STAFF RECOMMENDATION 1406 Fifth Avenue North June 15, 2016

Application: New construction—addition, reconstruction, outbuilding (detached accessory dwelling unit)

District: Germantown Historic Preservation Zoning Overlay

Description of Project: Application is to reconstruct a front porch and construct a side porch and outbuilding that includes a detached accessory dwelling unit.

SITE PLAN

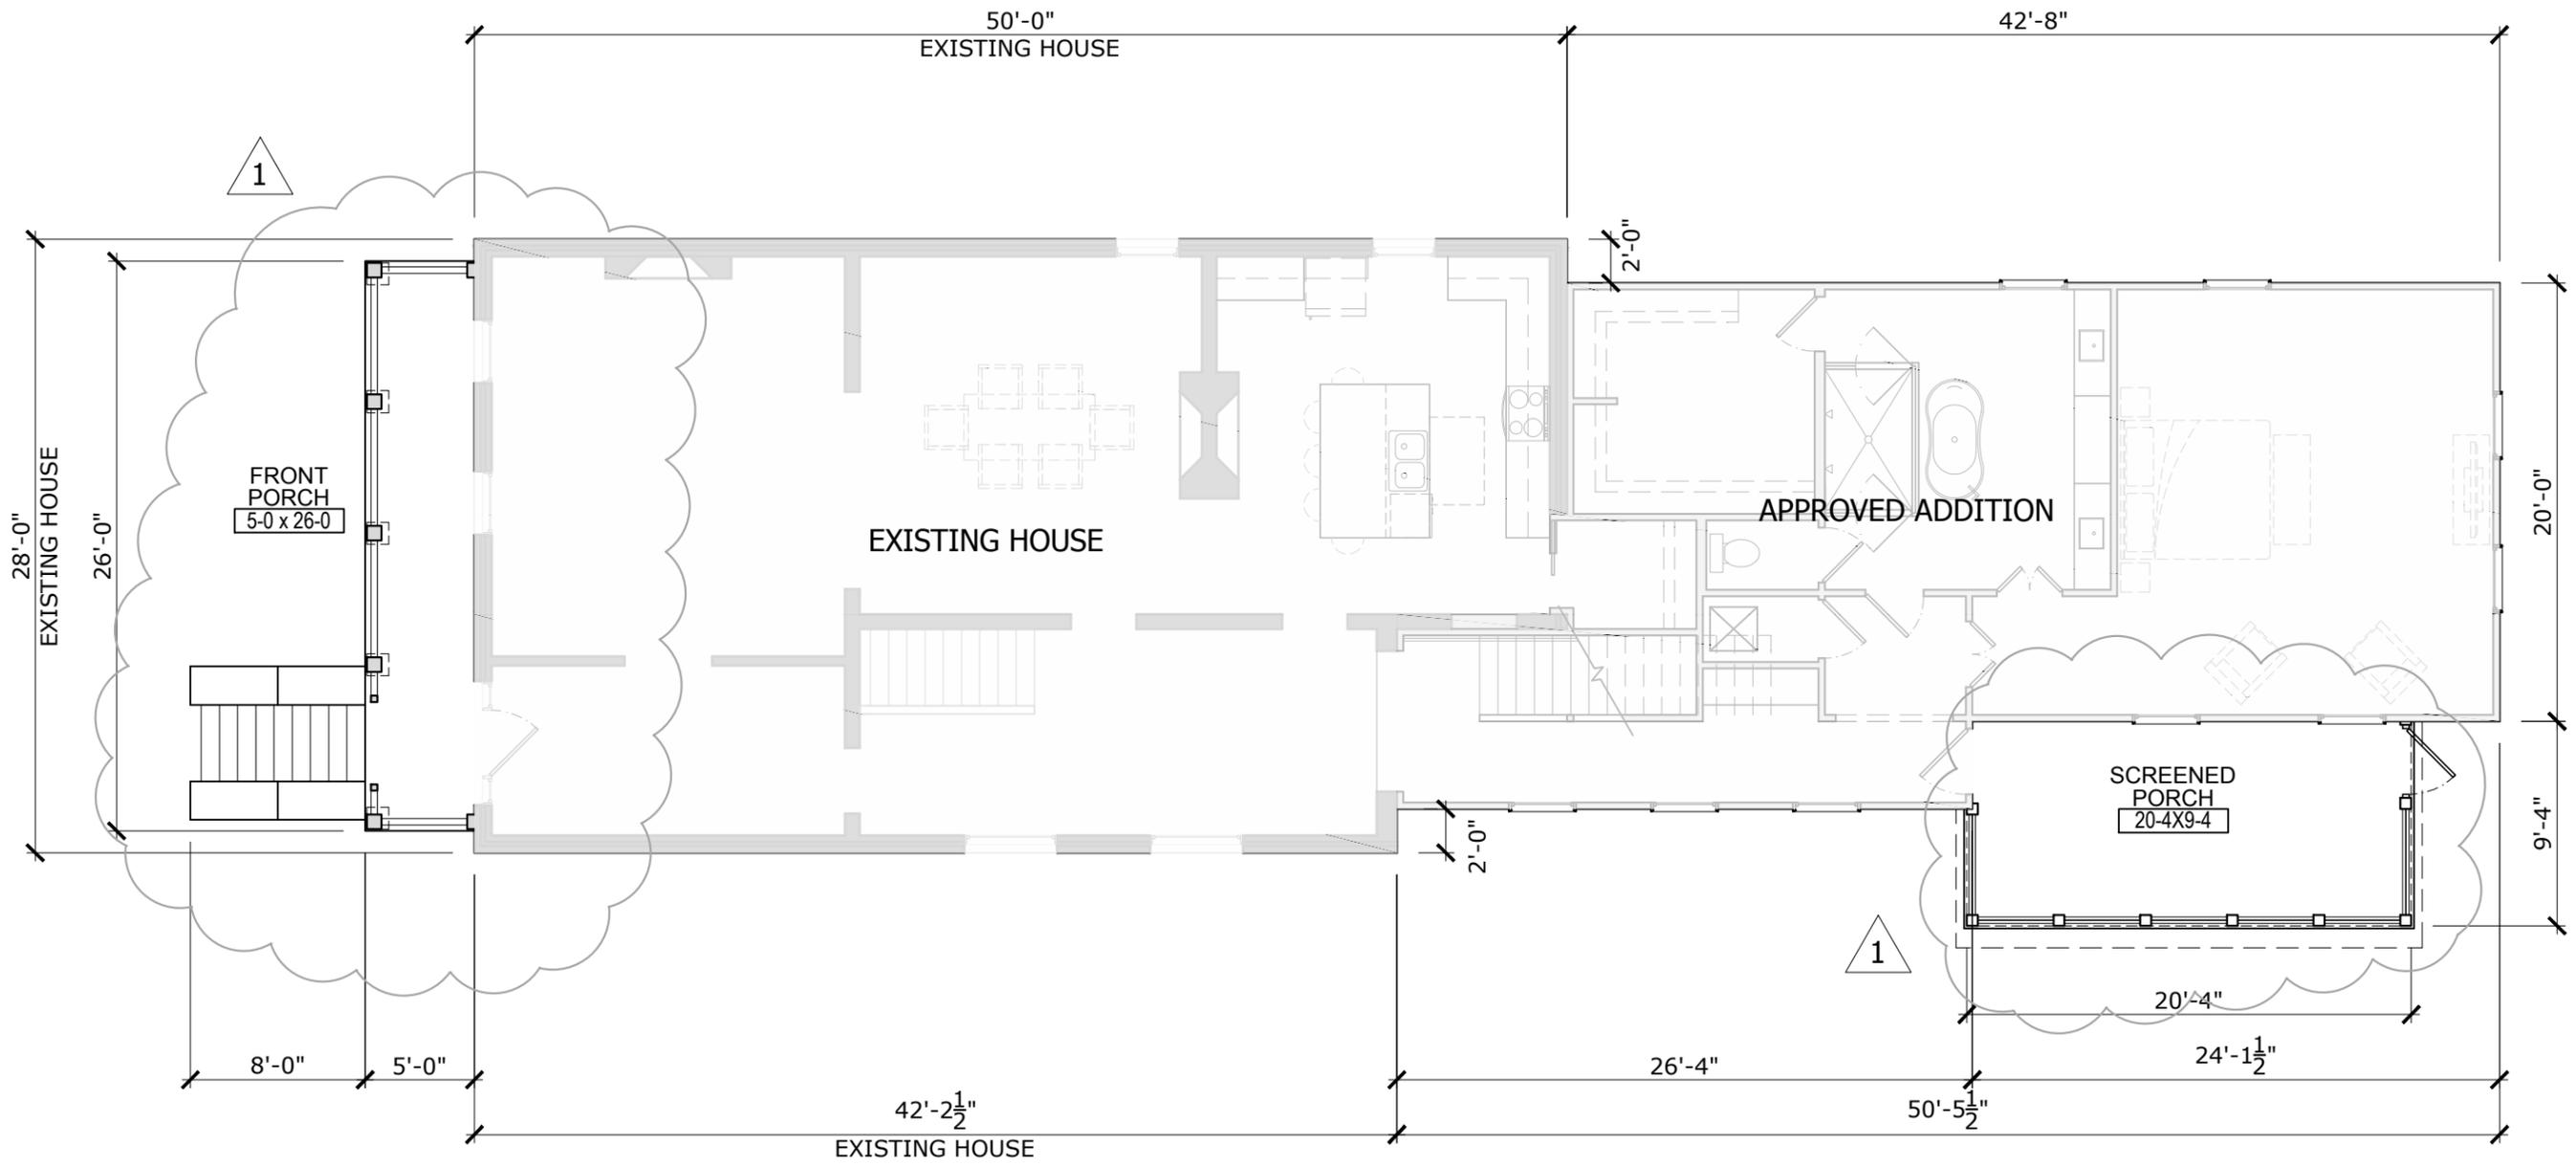
Setbacks: The outbuilding will be located behind the house, separated from it by approximately fifteen feet (15’). Outbuildings are typically required to sit at least twenty feet (20’) from the principal building, however this house has a greater front setback than most historic houses nearby which gives it a shorter rear yard. For that reason, Staff finds the location to be appropriate. The left (north) setback will be three feet (3’) and the right setback will be sixteen feet (16’). These setbacks are appropriate and meet the zoning requirements. The rear setback proposed is five feet (5’). For a building with a footprint greater than seven hundred square feet (700 sq. ft.) the standard setback is ten feet (10’). Staff finds the proposed setback to be appropriate because it is more like the typical location of outbuildings historically, and it allows for greater separation between the outbuilding and the house. The project meets Section 2.9.2 of the design guidelines.

MINIMUM	PROPOSED
Space between principle building and DADU/Garage	20'	14'
Rear setback	3'	5'
L side setback**	3'	3'
R side setback**	3'	16'
How is the building accessed?	From the alley or existing curb cut	Alley and existing curb cut

Recommendation Summary: Staff recommends approval of the new outbuilding with a five foot (5’) rear setback with the following conditions:

FRONT PORCH ELEVATIONS

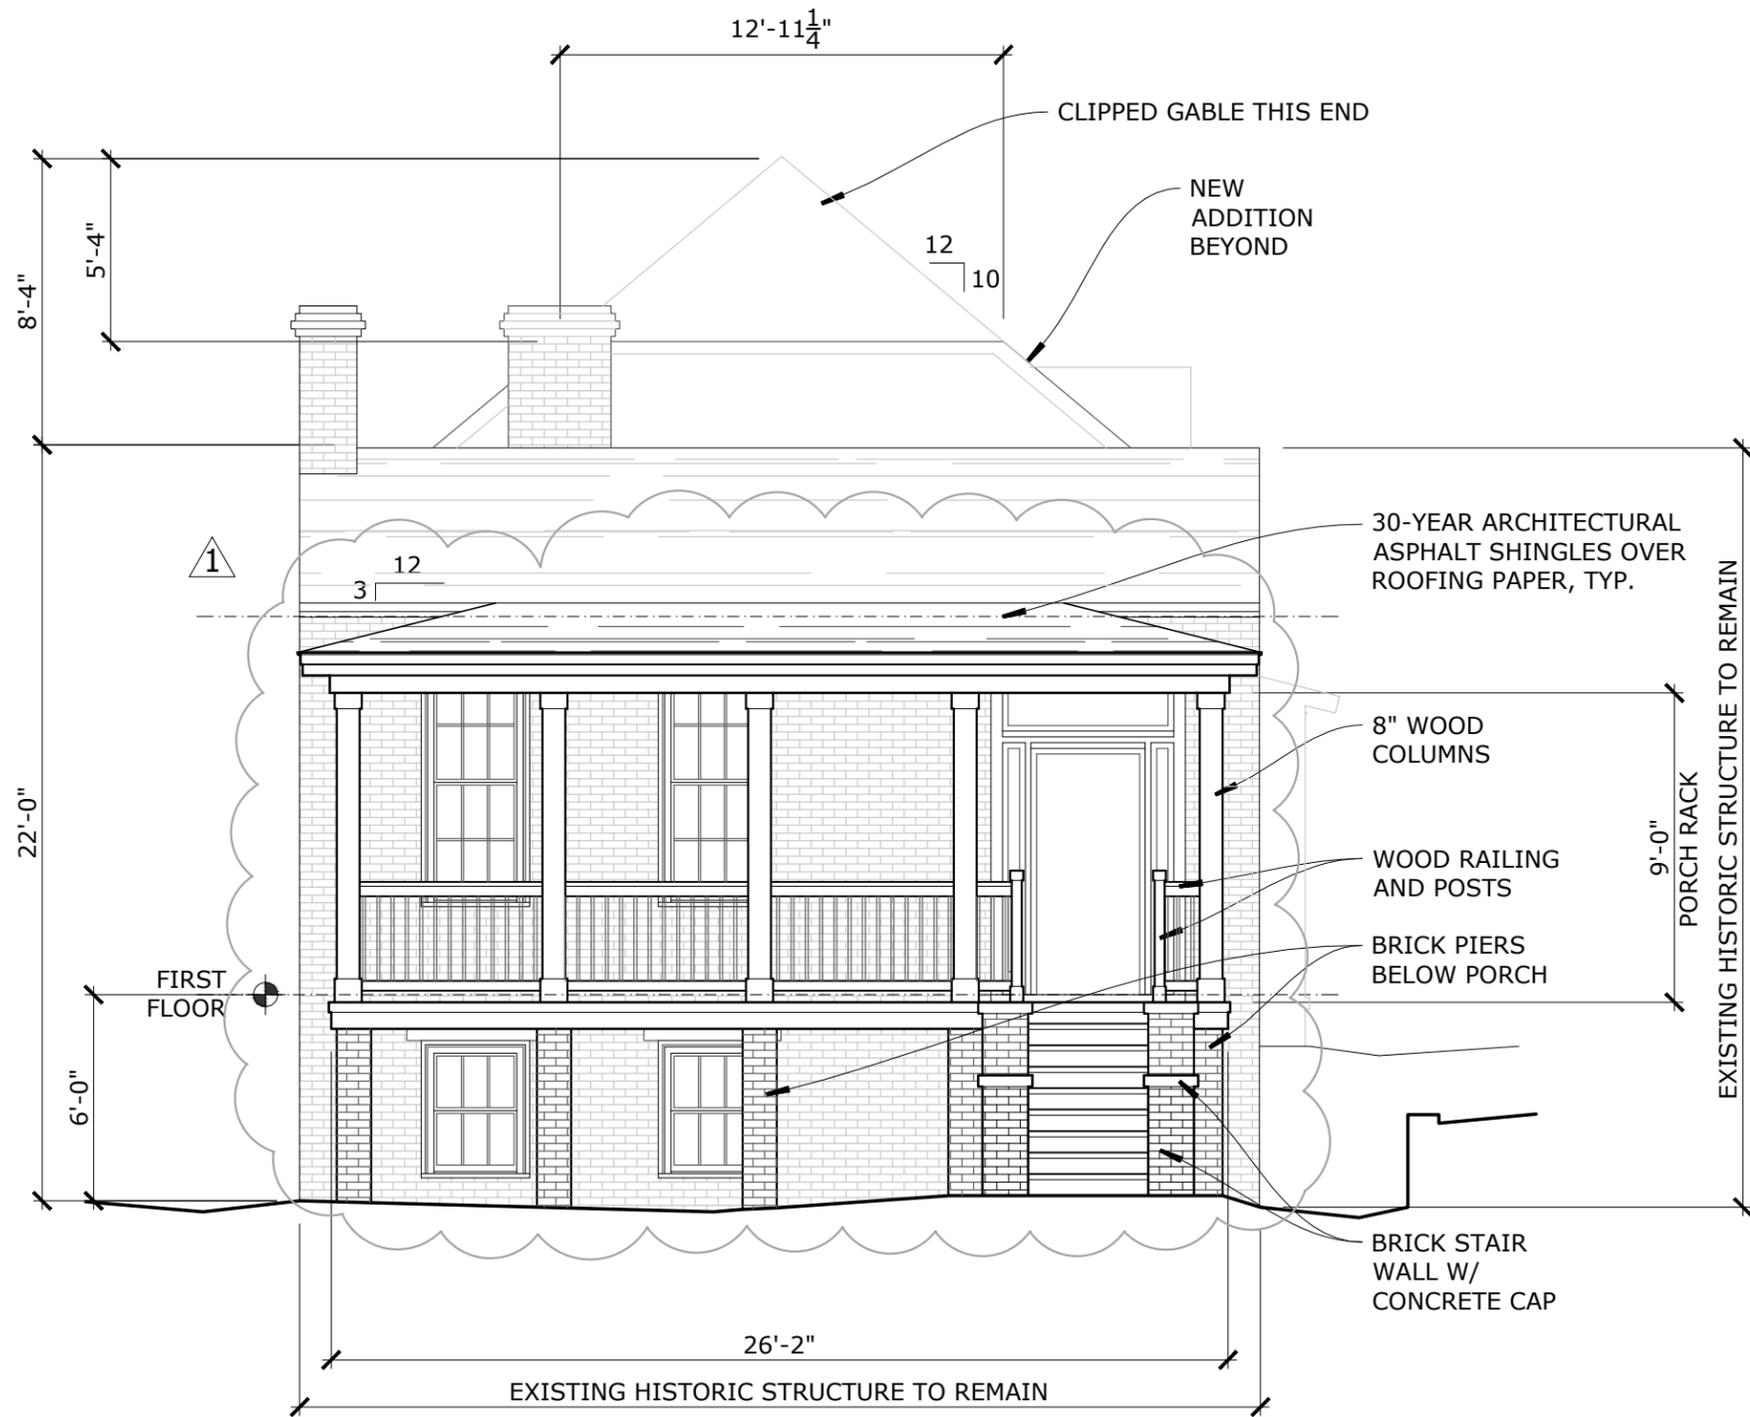
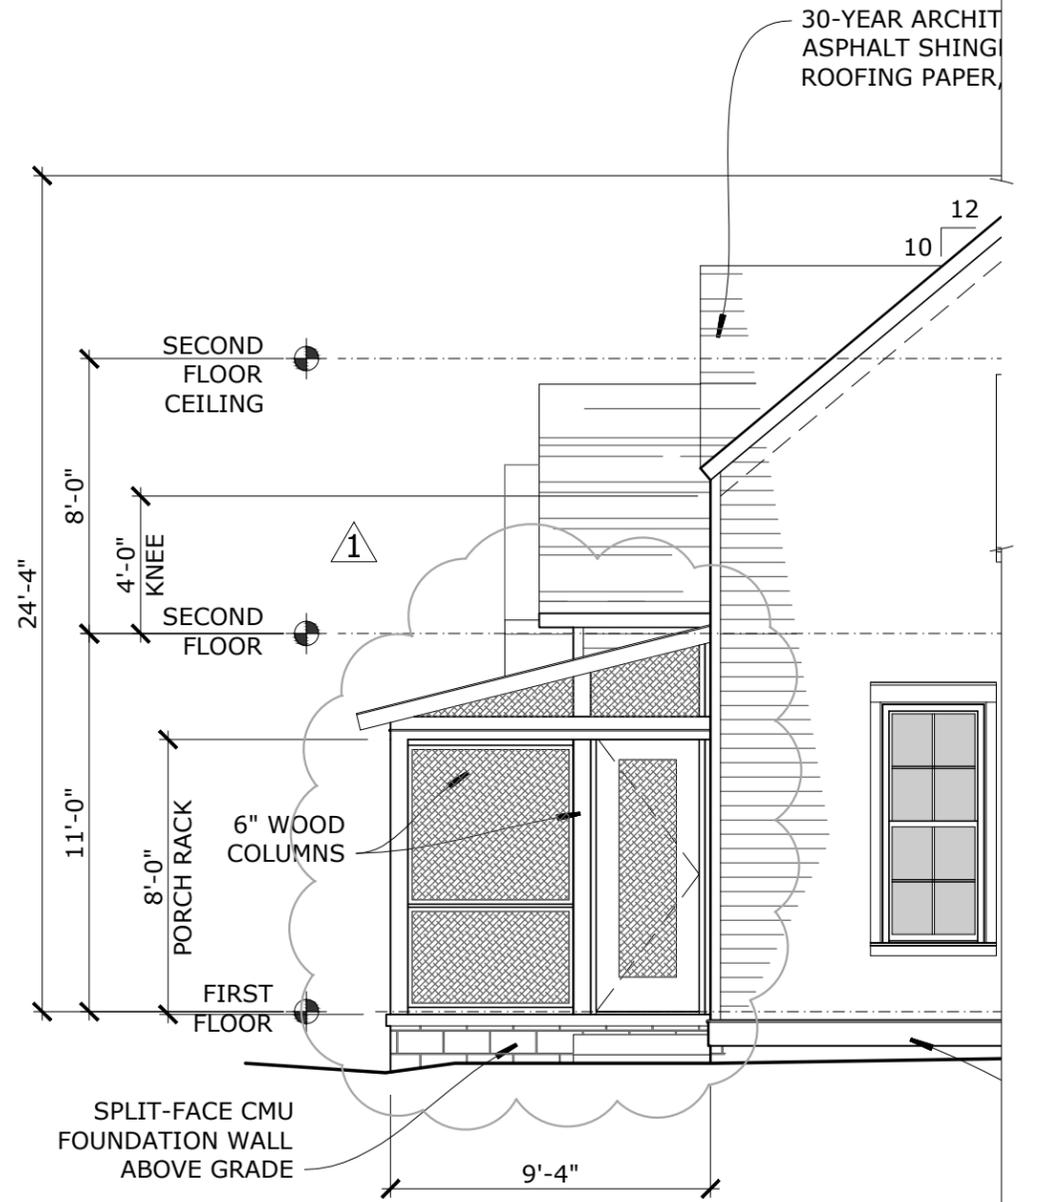
Alterations to an Historic House, Reconstruction: The applicant proposes to construct a full-width front porch, with a footprint matching that of the porch shown on the 1914 Sanborn map. Although the house did not originally have a full-width porch, it did have one added that remained long enough to have historical significance of its own. For this reason, Staff finds that reconstructing a full-width porch is appropriate.

The roof of the porch will be hipped, tying into the front of the house at the bottom of the front eave line. The porch floor height will match that of the existing front porch. The porch will have five square columns along the front edge. The roof form and column configuration are similar to the porch depicted on the circa 1970 photo. Staff finds that because the porch depicted in the c. 1970 photograph may not be the exactly the original design, staff found that a similar configuration is appropriate. The differences are minimal including hipped roof rather than shed and slightly different pier configuration but still with an open basement level. The project meets section 2.1.5 for reconstruction.

Material & Design: The roof will be asphalt shingles matching the existing roof, the columns and railing will be wood, and the foundation will be brick piers. The design of the porch is simple with square posts and balustrade, which is appropriate when the exact design and dimensions are unknown to prevent creating a false sense of history. Staff finds that the proposed porch is compatible in size and material, and that the hipped roof and column configuration are typical of porches on houses of this age and style. The known materials meet sections 2.4.6, 2.1.4 and 2.1.5 of the design guidelines.

Site and Building Planning: The existing house sits approximately eight feet farther from the street than most buildings on the block face. With the reconstruction of the eight-foot (8') deep front porch, the resulting setbacks will maintain the prevailing rhythm of the context. Staff finds this to meet sections 2.2.1 and 4.2 of the design guidelines.
